E8257D-29

S E R V I C E N O T E

E8257D Analog Signal Generator

A self-test error 1203 occurs when replacing a 40 GHz doubler with replacement part 5087-7717.

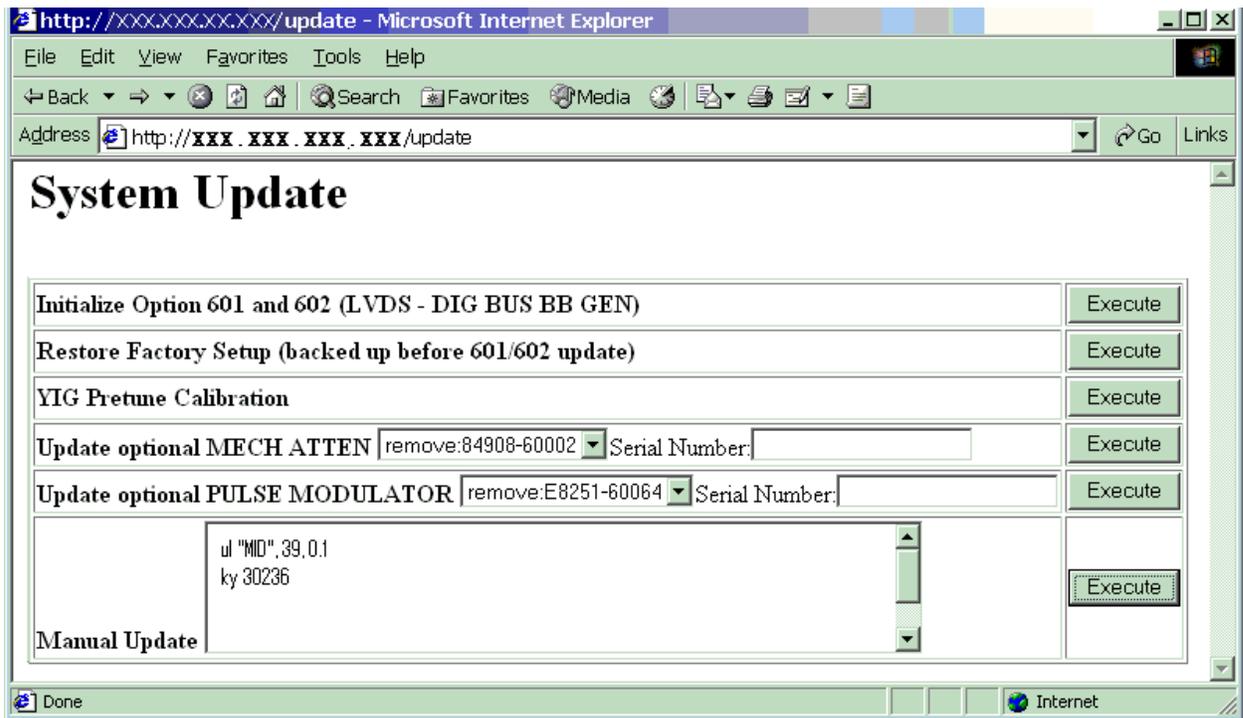
Situation: The new 40 GHz Doubler, part number 5087-7717 is replacing 5087-7064. When replacing part 5087-7064 with the new part number 5087-7717, the upper self-test limit of “DBLR bias off” needs to be updated. The upper self-test limit is 0.1.

1. When the 5087-7717 is replaced and self-test 1203 fail, verify the self-test limit by pressing: Utility, Instrument Information/Help Mode, Self-Test, and View Test Info.
2. Using the RPG or up and down arrow keys scroll to self-test 1203. Press: Run Highlighted Test.
3. When self-test is completed press: View Details. Using the RPG or up and down arrow keys scroll to the “DBLR bias off” upper limit should be 0.1.

“DBLR bias off” Lower = -7 Upper = 0.1

4. If the upper self-test limit is correct continue to troubleshoot the problem using the troubleshooting procedure in the service guide.
5. If the upper self-test limit is not correct, update the self-test limit.
